# DOWNTOWN DESIGN REVIEW BOARD

RECOMMENDATION BOOKLET

# 600 WALL STREET

SEATTLE, WASHINGTON | DPD# 3015251 | JANUARY 06, 2015

**3 Rendered Elevation - Wall St**  
 A5.01 Scale: 1/16" = 1'-0"

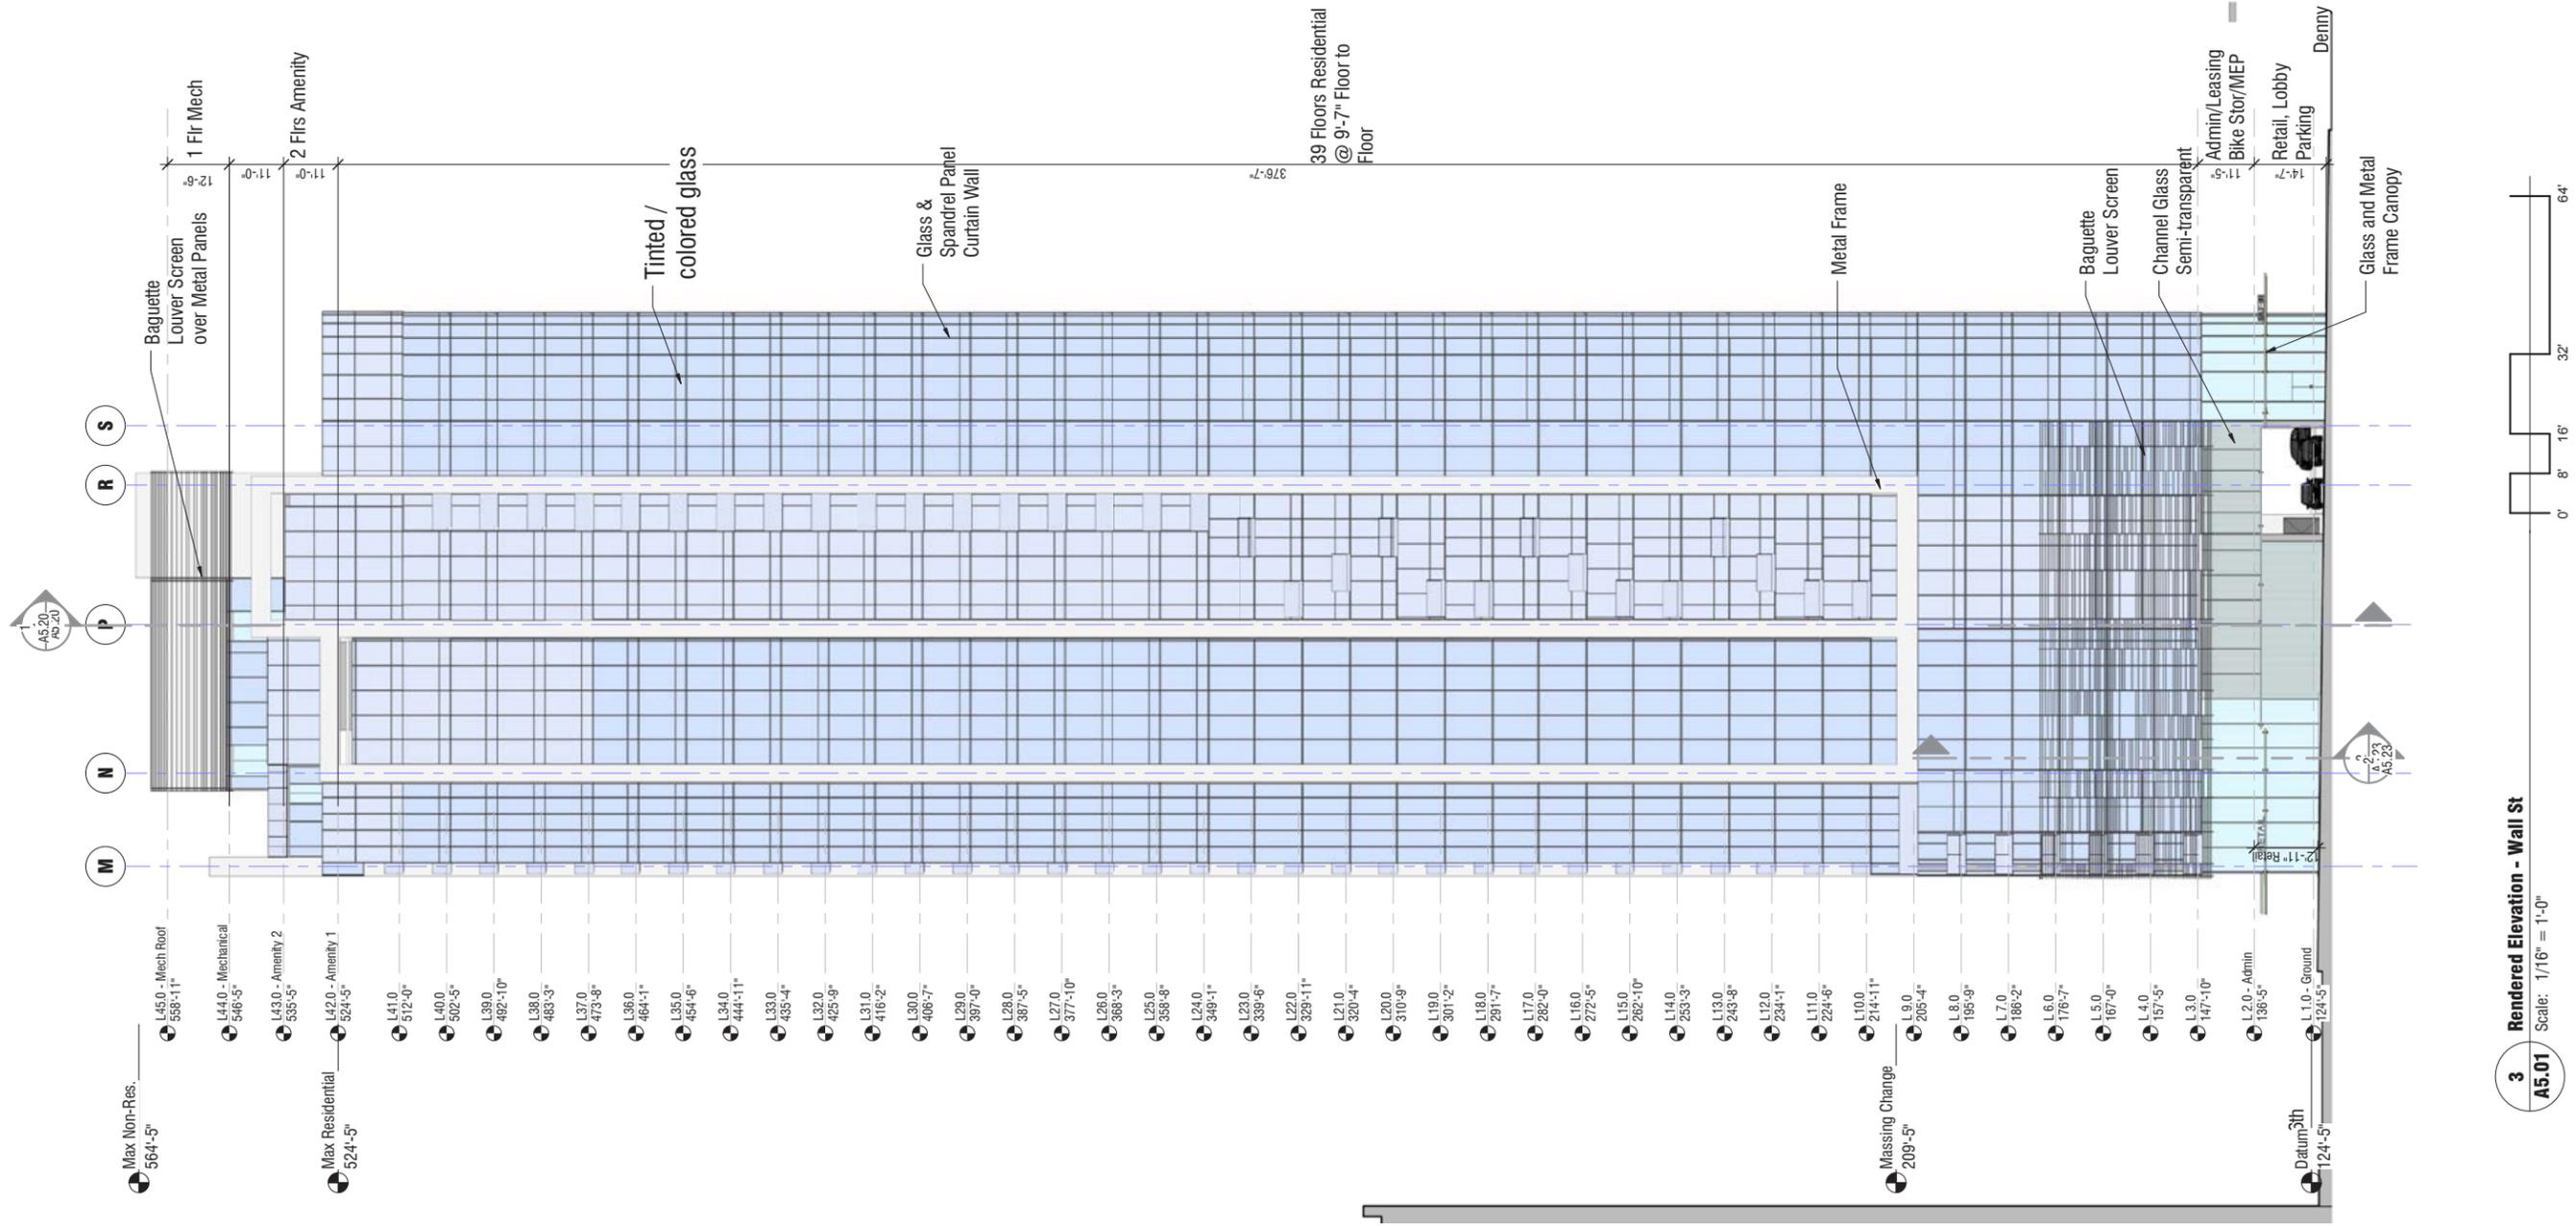
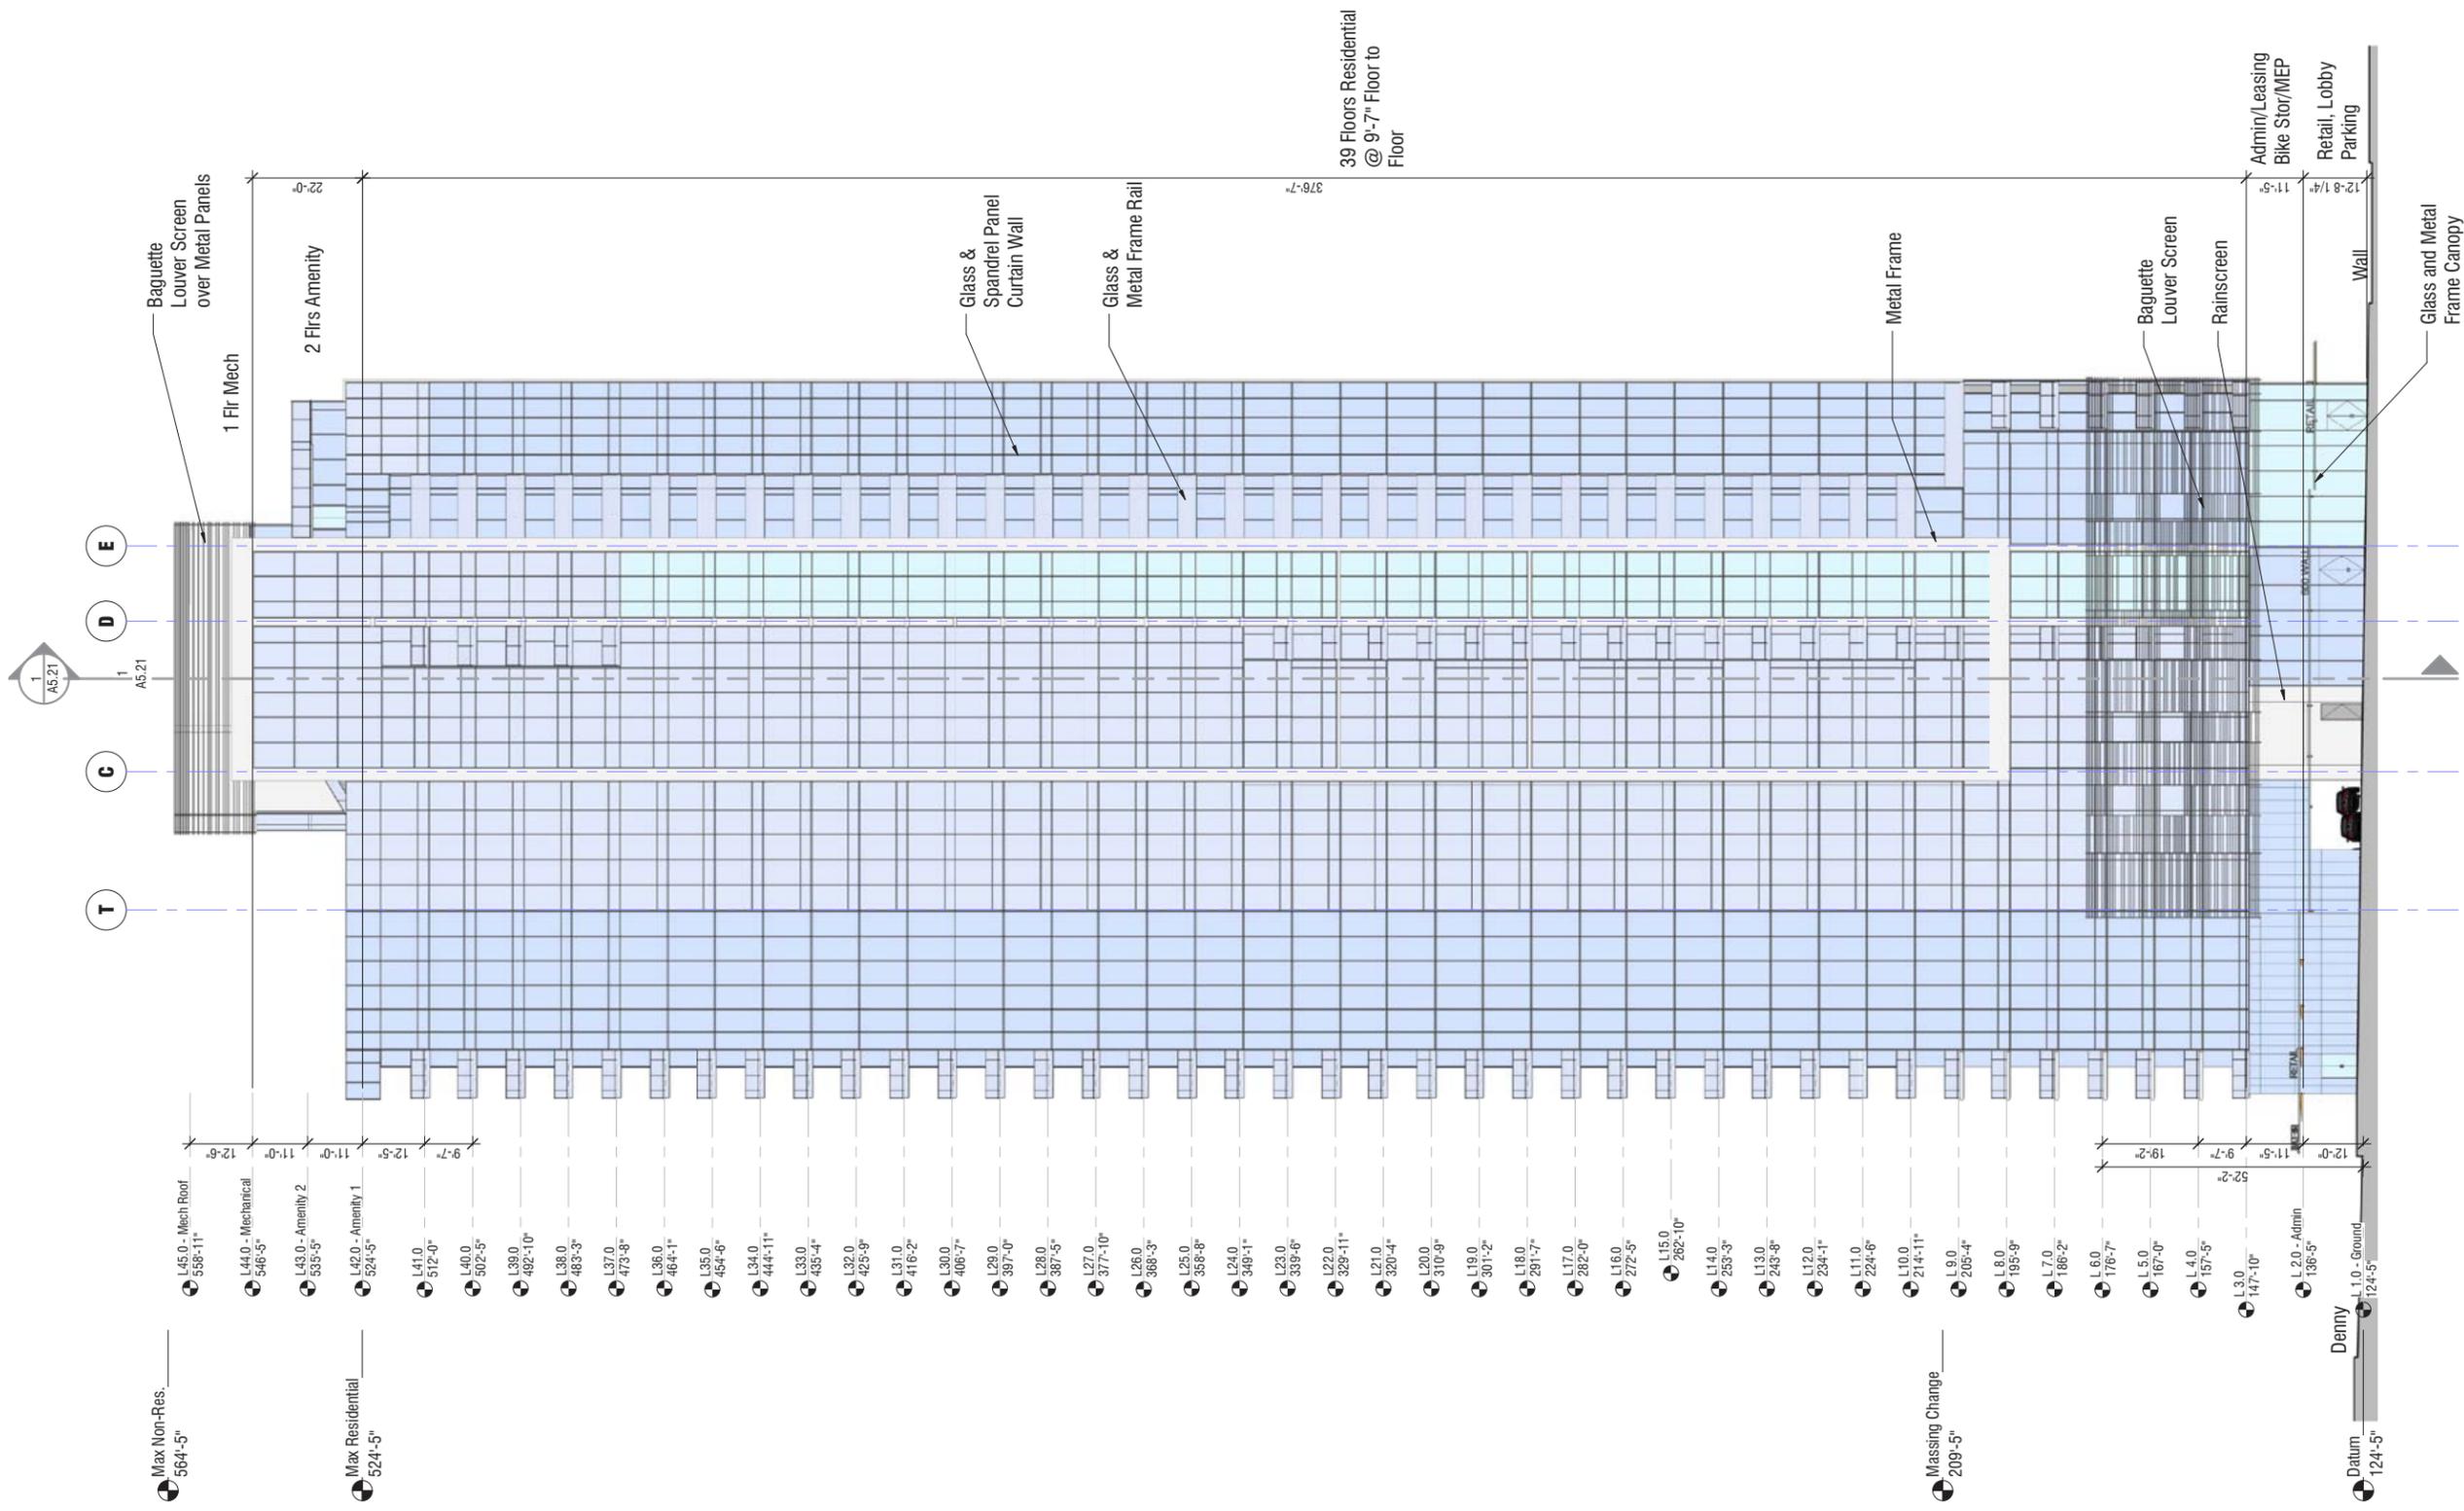
At the Early Design Guidance Meeting #2, the Board understood the below-grade excavation constraints and agreed the podium uses are much improved, in particular the amenity spaces on Denny. The Board supports the car share spaces on P-1. They discussed how the podium issues described in B-2 must transition well into the middle of the tower. To better evaluate this, the Board requires:

- Full page elevations with complete color and material notes.
- Large scale sections of the first 7-8 floors, showing dimensions and all façade elements (the ones shown on pages 36/37 are too small; ¼ inch scale preferred). NOTE: these should be composited with the landscape-only sections shown on pages 32-34.
- Large scale partial elevations (floors 7-8) adjacent to corresponding sections, which show all materials and light tone shadows, but not street trees.

The Board agreed the four white frames on the mid-tower provide middle scale to the three elevations, but they appear to be thin planes; show more details that establish the materiality and depth of these elements (as suggested by the white wall returns on pages 45,47 and 49), and show these accurately on floor plans. Also, explore the following as part of the elevation refinements:

- Explore a 2-3 floor transition between the podium and middle tower, starting the white frames at floorline 9 or 10 rather than 8.
- Explore the white frames along Denny starting above the podium, and not overlapping with the podium amenity expression, as currently shown on page 51.
- Explore reducing the width of the white frame elements, and/or their identical material/color nature on all three street frontages.
- To test these relationships, provide perspective studies like on pages 45,47,49, but that extend further upward into the tower.

- The frame has been redesigned to start at level 7, providing a 3 level transition between the podium and middle tower.
- The frame as previously applied is located in front of continuous building planes. To add more thickness to the frames would require reducing floor areas significantly. Instead, they have been redesigned to define the change in plane where the areas inset in the frames are deeper, varying from 1 foot at 6th and Denny streets and 2 feet at Wall.
- The metal panels at the inside of the frame continue at balconies that are adjacent to the frame providing more depth and variation.
